Access Compliance Report

Public Rights-of-Way

Intersection ID: 11625	Main Street: E_11TH_ST	Cross Street: N_COLLEGE_ST	Location: E
ADA ID: 768469B7B7AE	Ramp Type: Perp	Initial Pass/Fail: Fail	Overall Compliance: No
Severity Score: 12.5			
Codes/Mitigation Info/Possible Solution		Field Measurements/Component Compliance

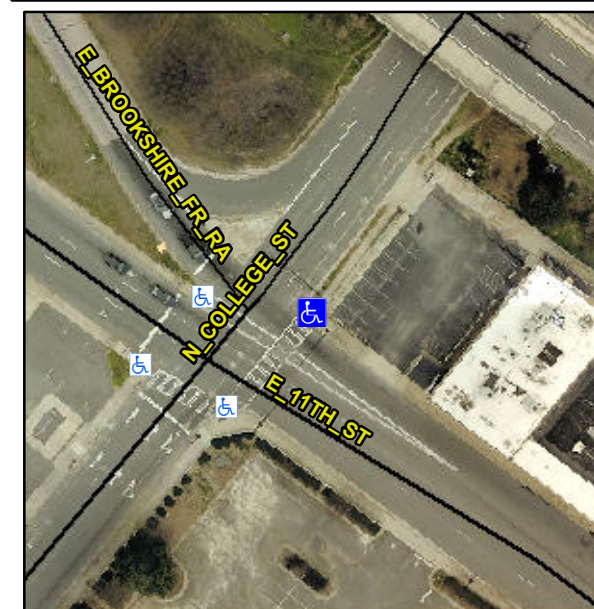
Not Found, R304.2.2

Compliance	Description	Data	Compliance	Description	Data
N/A	Ramp Length (in)	48.0	No	Ramp Slope (%)	10.2
Yes	Ramp Width (in)	48.0	Yes	Ramp XSlope (%)	1.4
N/A	Flare Type LT	N/A	N/A	Flare Type RT	N/A
N/A	Flare Slope LT (%)	N/A	N/A	Flare Slope RT (%)	N/A
N/A	Flare Traversable LT?	N/A	N/A	Flare Traversable RT?	N/A
N/A	Landing Length (in)	N/A	N/A	DWS Provided?	N/A
N/A	Landing Width (in)	N/A	N/A	DWS Contrast?	N/A
N/A	Landing Slope (%)	N/A	N/A	DWS Length (in)	N/A
N/A	Landing X Slope (%)	N/A	N/A	DWS Full Width?	N/A
N/A	Landing Curb? (Y/N)	N/A	N/A	DWS Offset (in)	N/A
N/A	Shared Landing?	N/A			
N/A	Gutter Ponding?	N/A	N/A	Gutter Slope (%)	N/A
N/A	Gutter Lip Ht (in)	N/A	N/A	Gutter X Slope (%)	N/A
N/A	Painted X Walk1?	Yes	N/A	Painted X Walk2?	N/A
	X Walk 1 Direction	To SW		X Walk 2 Direction	N/A
N/A	X Walk 1 Width (in)	112.0	N/A	X Walk 2 Width (in)	N/A
	X Walk 1 Slope (%)	4.1		X Walk 2 Slope (%)	N/A
	X Walk 1 X Slope (%)	2.2		X Walk 2 X Slope (%)	N/A

Remove & Replace Entire Ramp.
